# Attachment C

**DPS-ROW CONDITIONS OF APPROVAL**

**82009006A Montgomery Village Marketplace**

Re: Applications No. 12009009A and No. 82009006A (the “Applications”)  
Theater Pond Retrofit  
Proposed Applications to Develop a Child Care Center  
Applicant: Ganges Gaithersburg, LLC  
“The Learning Center Montgomery Village Marketplace”  
10001 Stedwick Road, Montgomery Village, MD  
 (“Lot 31”)<sup>1</sup>

**SITE DEVELOPMENT - STORMWATER MANAGEMENT PLAN**

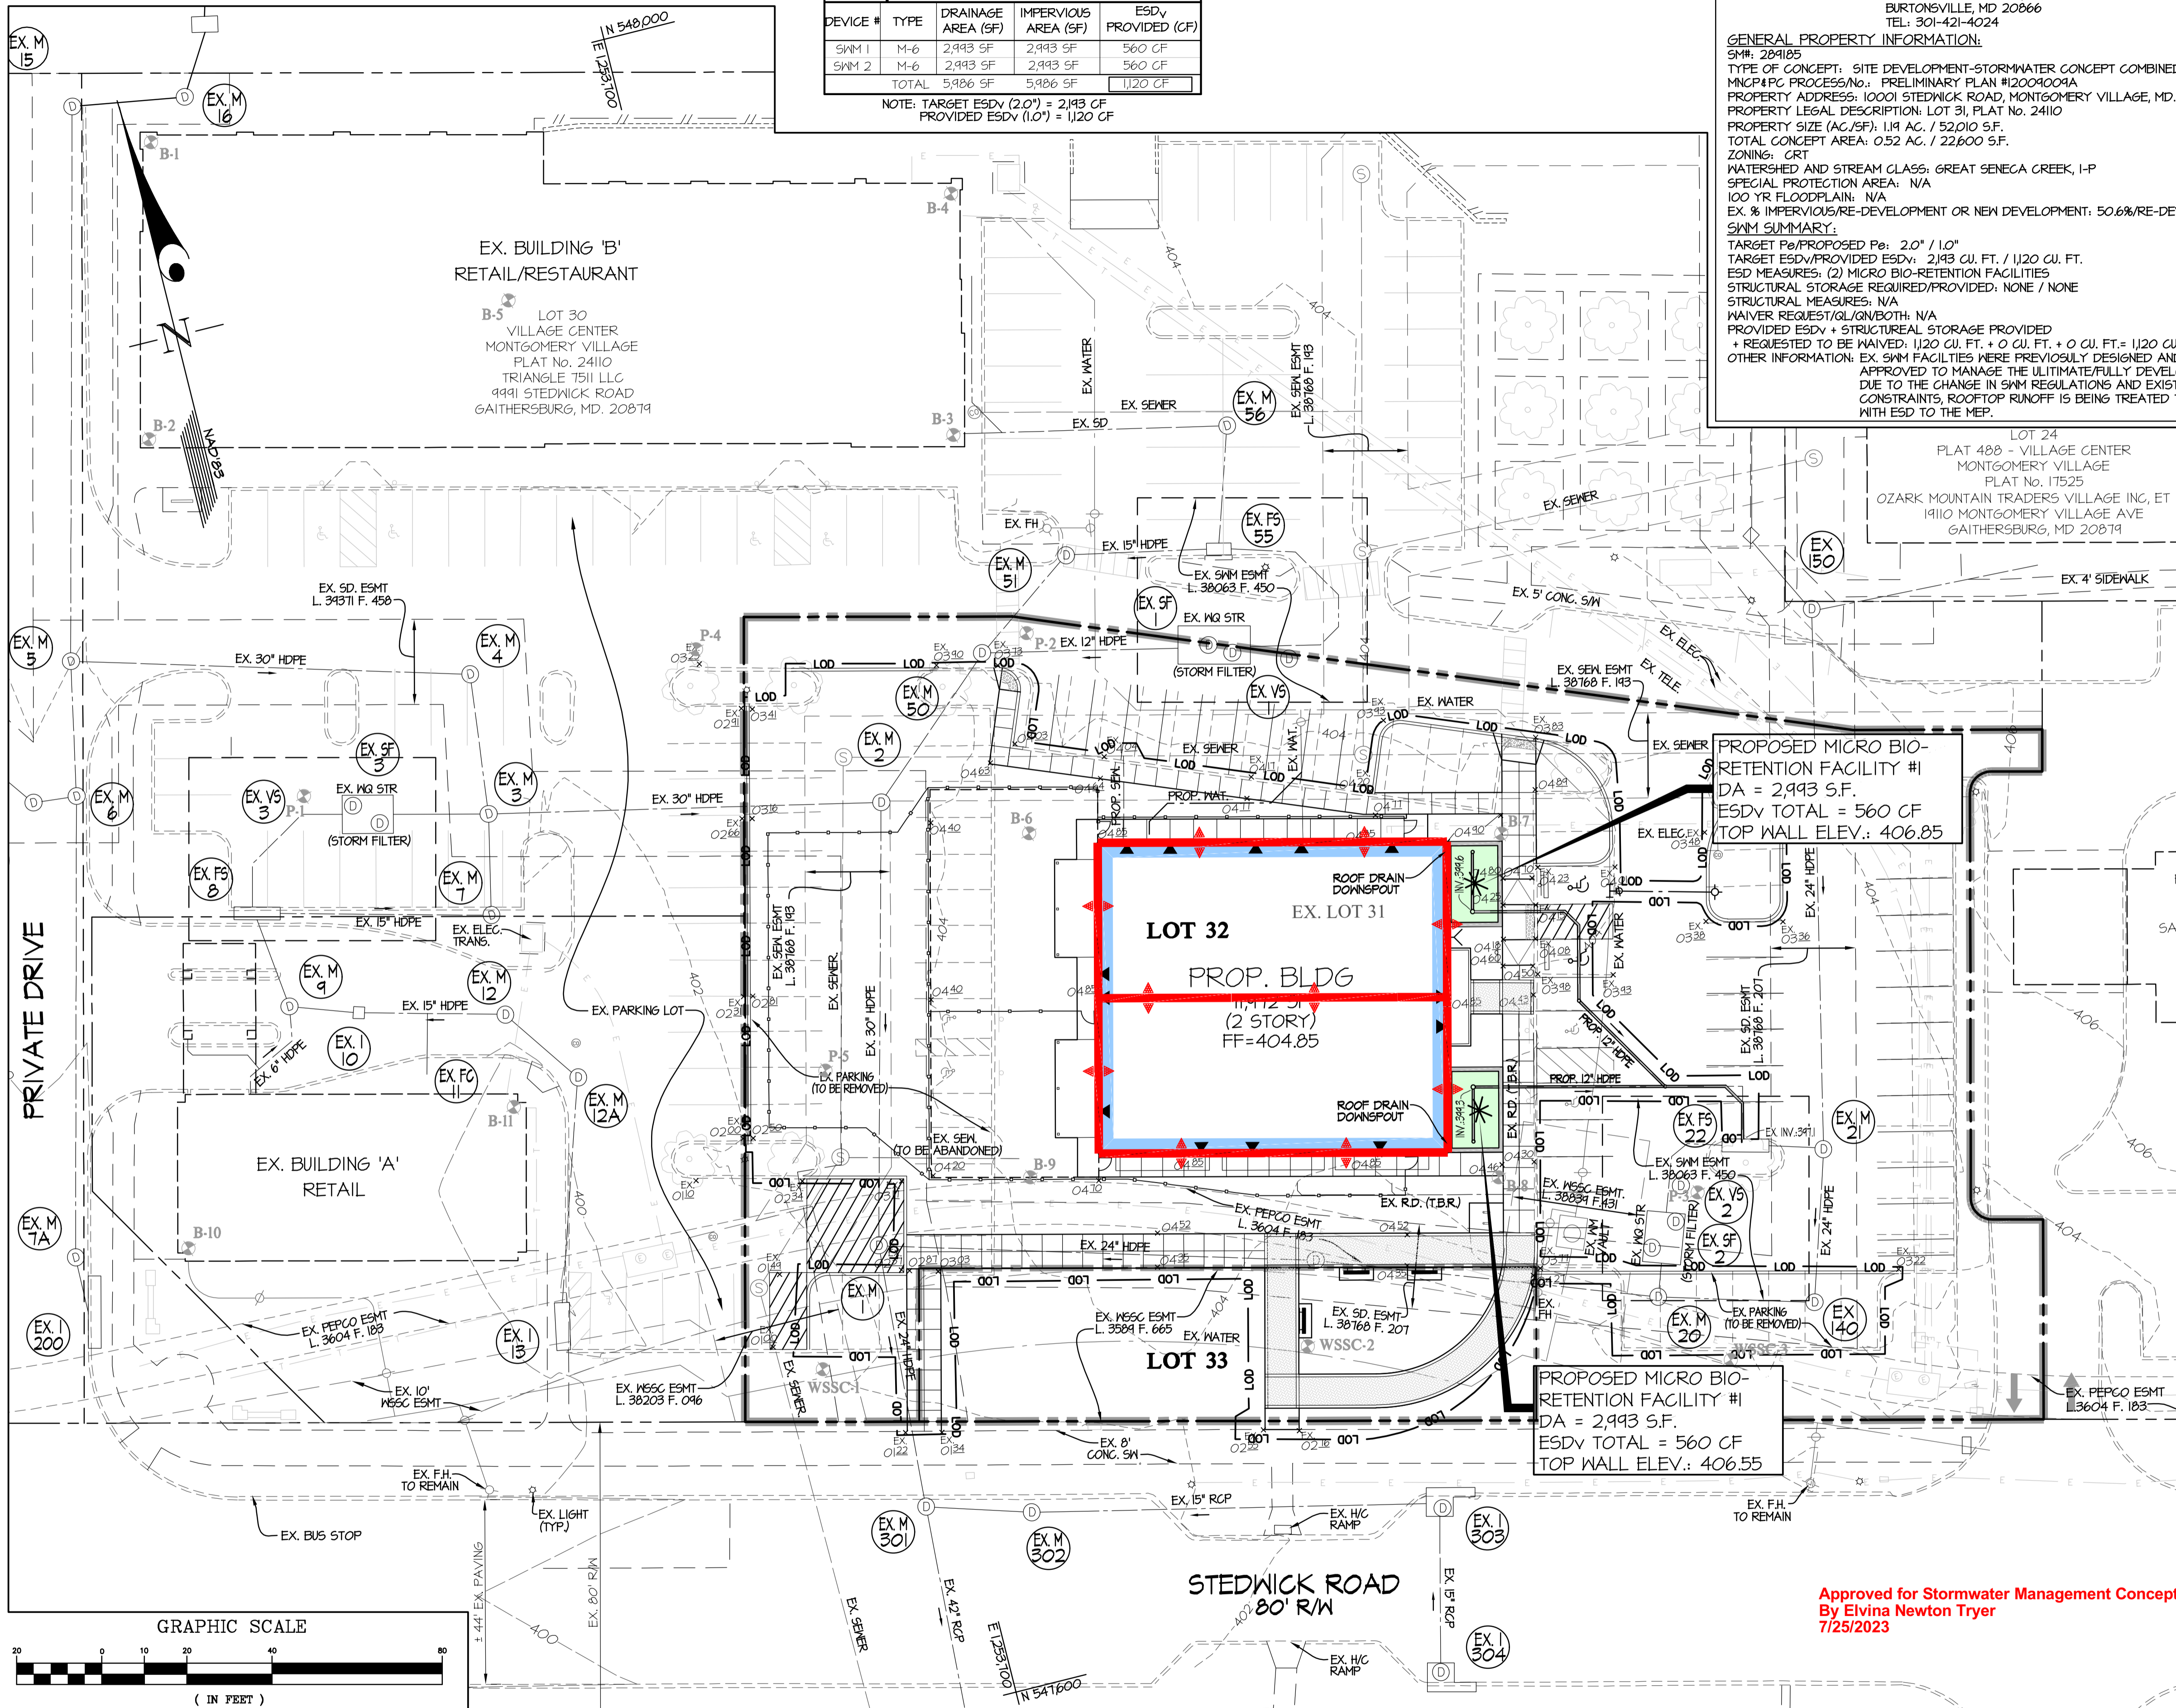
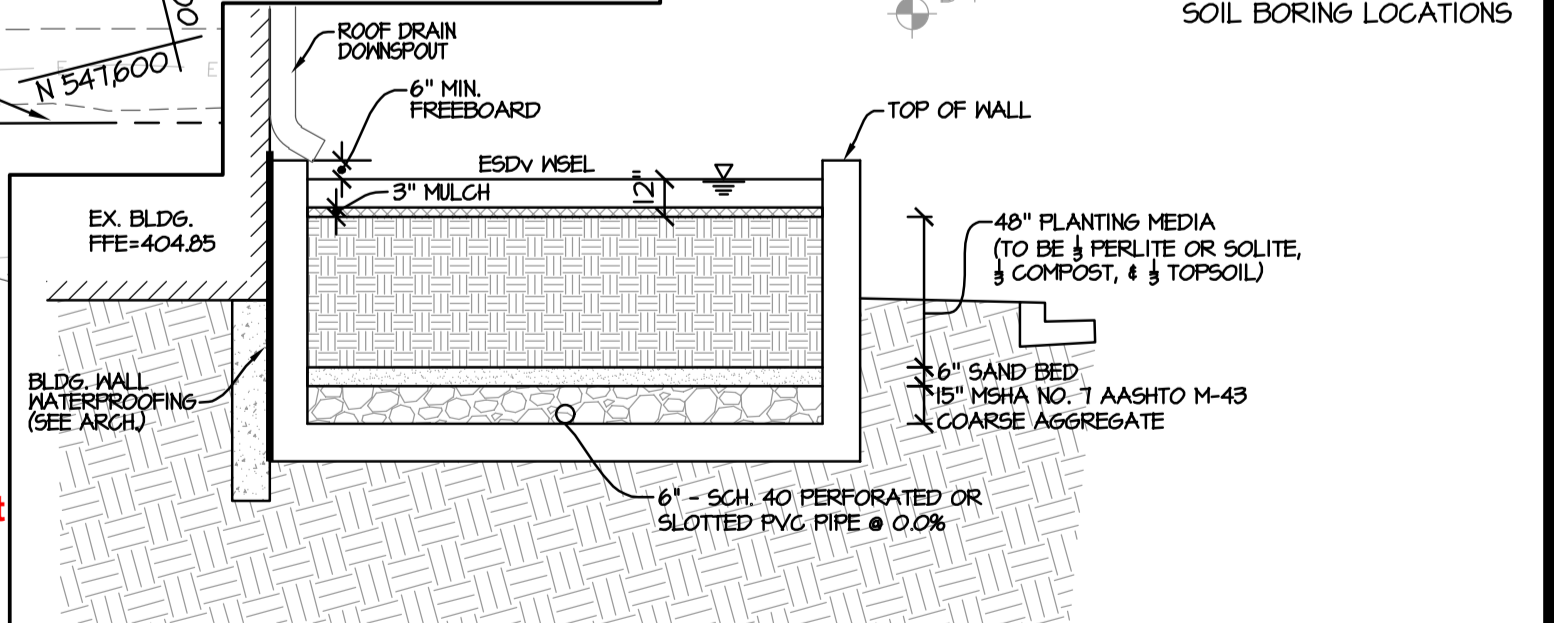
Based on a review by the Department of Permitting Services Review Staff, the stormwater management concept for the above-mentioned site is **acceptable**. The plan proposes to meet required stormwater management goals via the use of Planter Box Micro-Bioretenion practices. Full stormwater management compliance for the project could not be provided due to site constraints, resulting in a request for a partial stormwater compliance waiver. The waiver is hereby granted.

The following items will need to be addressed during the detailed sediment control/stormwater management plan stage:

1. A detailed review of the stormwater management computations will occur at the time of detailed plan review.
2. An engineered sediment control plan must be submitted for this development.
3. All filtration media for manufactured best management practices, whether for new development or redevelopment, must consist of MDE approved material.
4. All stormwater management practices must comply with Water Resources Technical Policy No. 8.

**FIRE ACCESS PLAN EXHIBIT**  
**MONTGOMERY VILLAGE MARKETPLACE**  
 EXISTING LOT 31, PROPOSED LOTS 32 & 33  
 VILLAGE CENTER - MONTGOMERY VILLAGE  
 PLAT No. 24110  
 GAITHERSBURG ELECTION DISTRICT No. 09  
 MONTGOMERY COUNTY, MARYLAND  
 G. L. W. FILE No.  
 22053  
 SHEET  
 1 OF 1

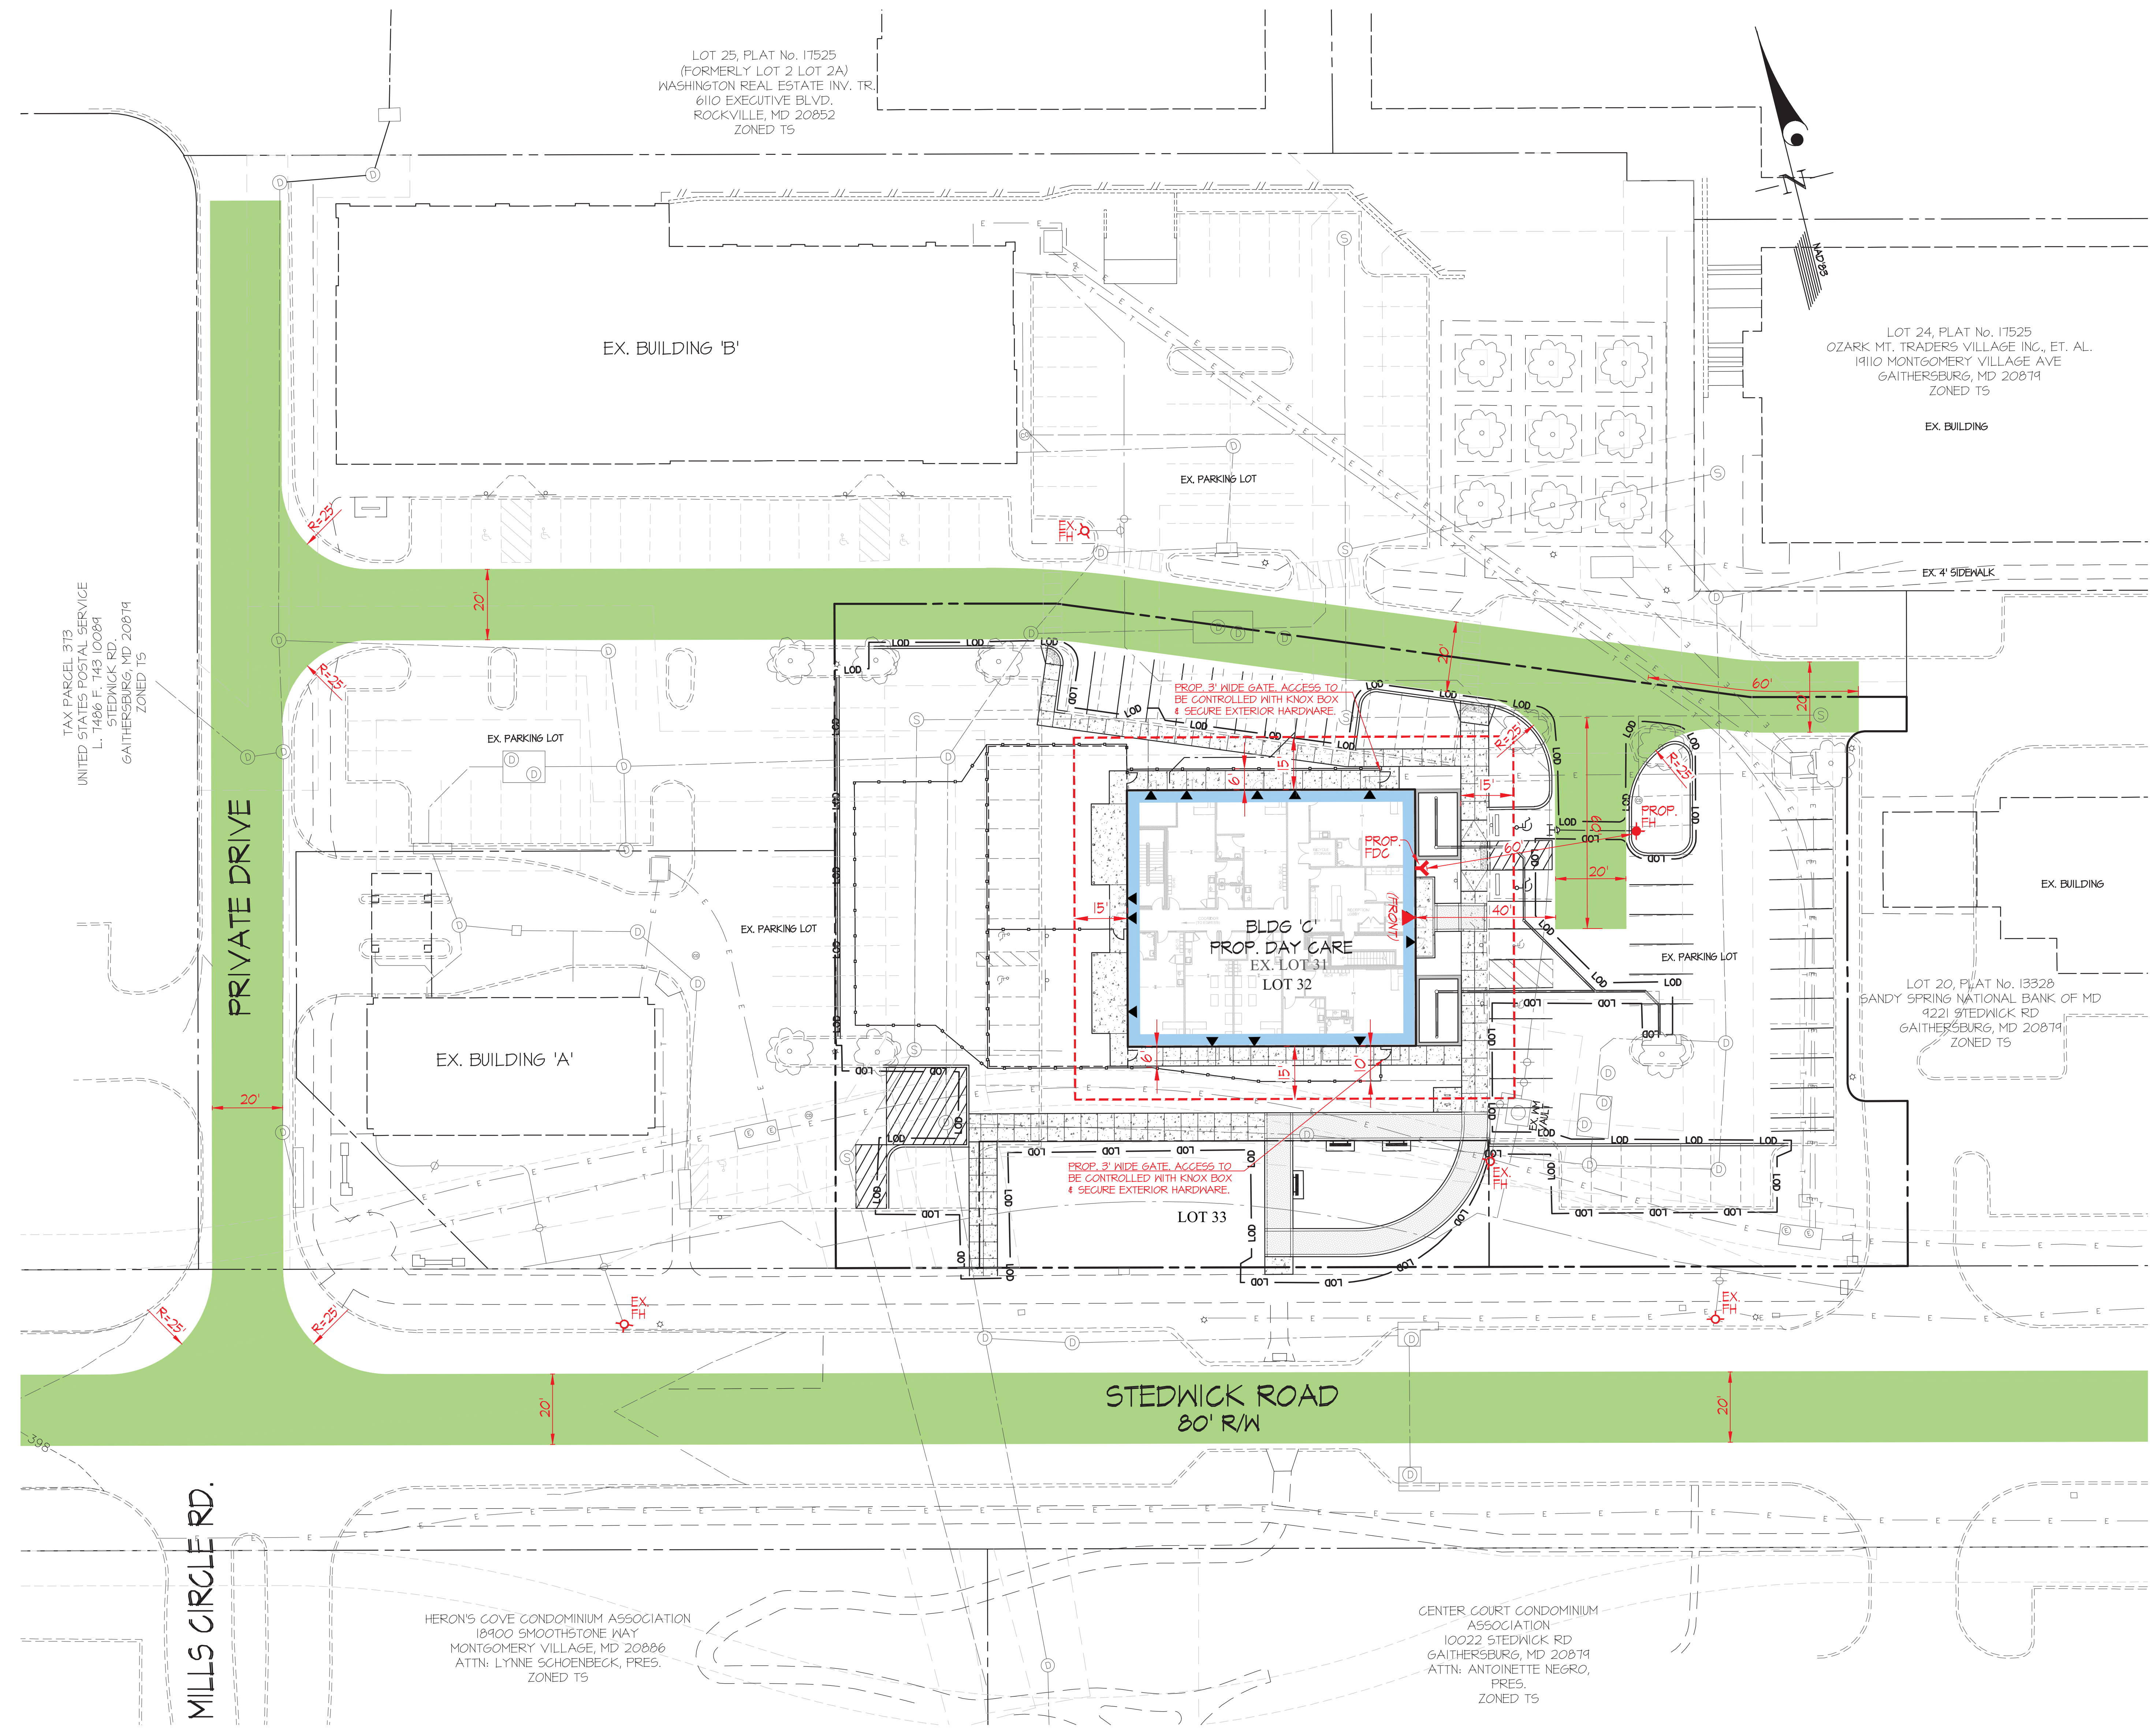
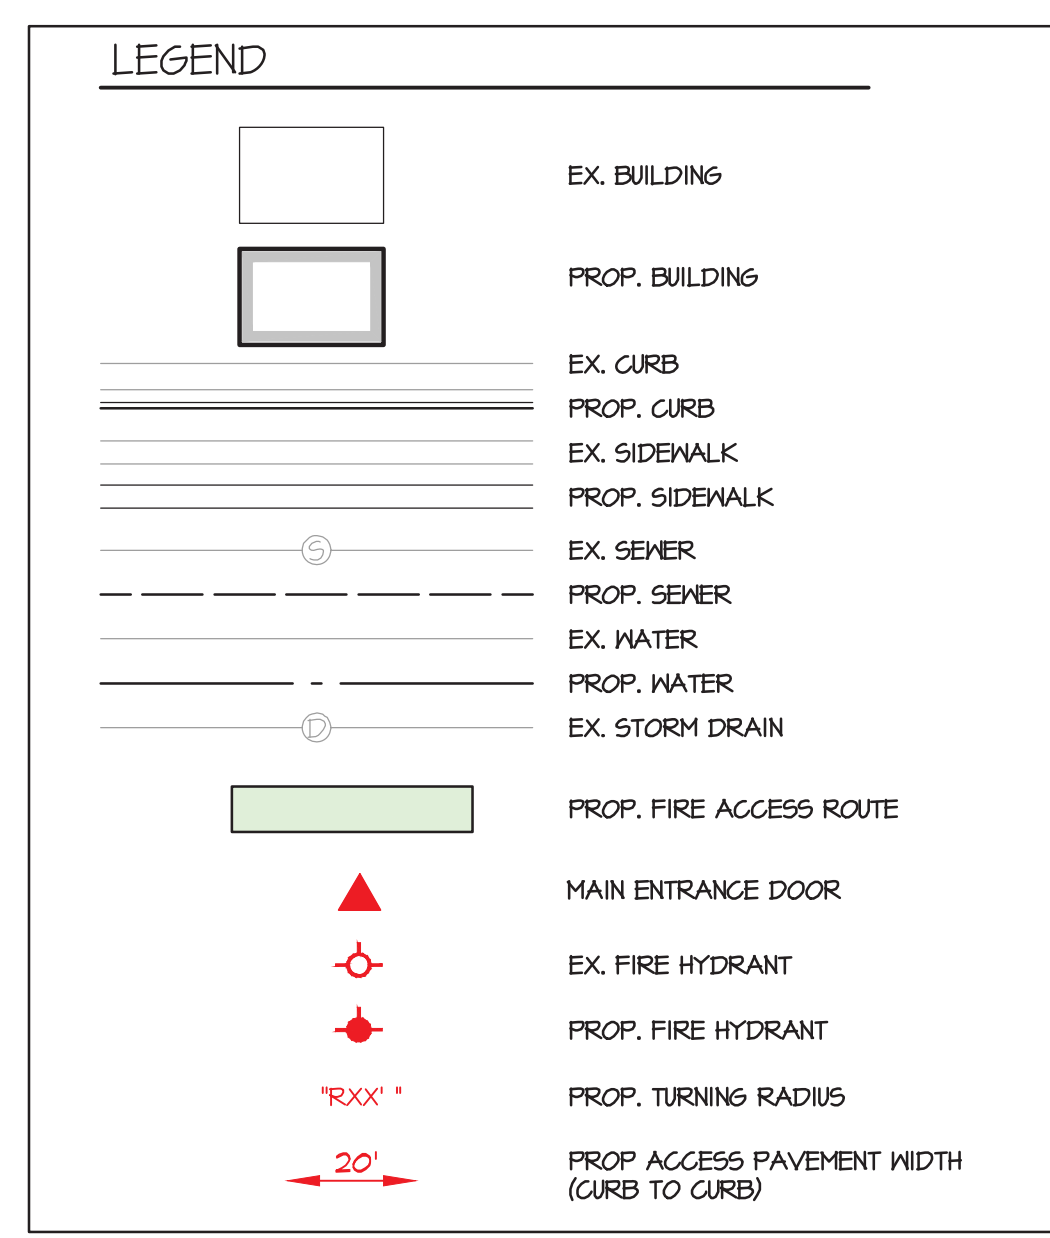
**PLAN APPROVED**

1. Review based only upon information contained on the plan submitted **26-Mar-09**. Review and approval does not cover unsatisfactory installation resulting from errors, omissions, or failure to clearly indicate conditions on this plan.
2. Correction of unsatisfactory installation will be required upon inspection and service of notice of violation to a party responsible for the property.

**FIRE CODE ENFORCEMENT**  
 Fire Department Access Review  
 Review based only upon information contained on this plan. Does not cover unsatisfactory layout resulting from omissions, errors or failure to clearly indicate conditions on this plan. Correction of such unsatisfactory layout to afford required access will be required if found upon inspection after installation.  
 BY: SAC PK: 43 DATE: 7/11/2023
